Amended Response to October 19, 2023 Data Request

Bright Mountain Solar Project

Case No. 2022-000274

BRIGHT MOUNTAIN SOLAR, LLC'S AMENDED RESPONSE TO STAFF'S October 19, 2023, DATA REQUEST

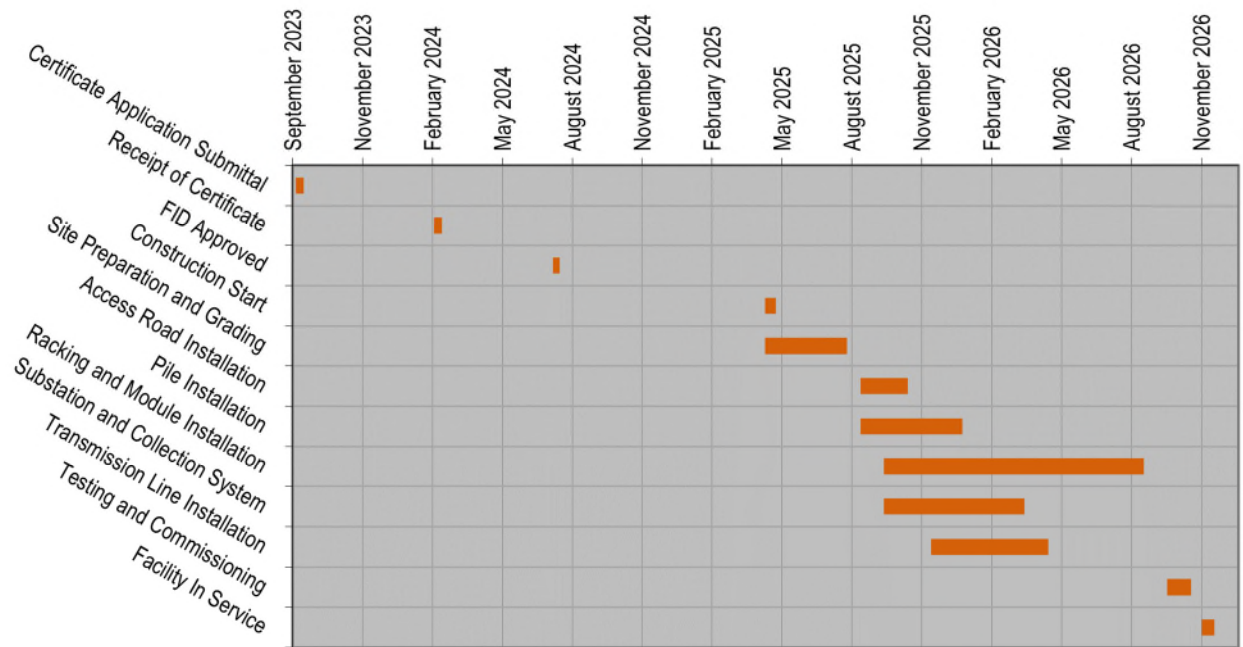
- 3. Provide a schedule for the project, starting from the receipt of the proposed certificate for construction to the completion of the project, including the length of each construction phase. Include in the response when Bright Mountain believes peak construction will occur within the timeline.**

A chart showing the anticipated Project schedule is below. Peak construction would likely be when pile driving activities begin through the installation of PV modules, anticipated to be approximately August 2025 to August 2026.
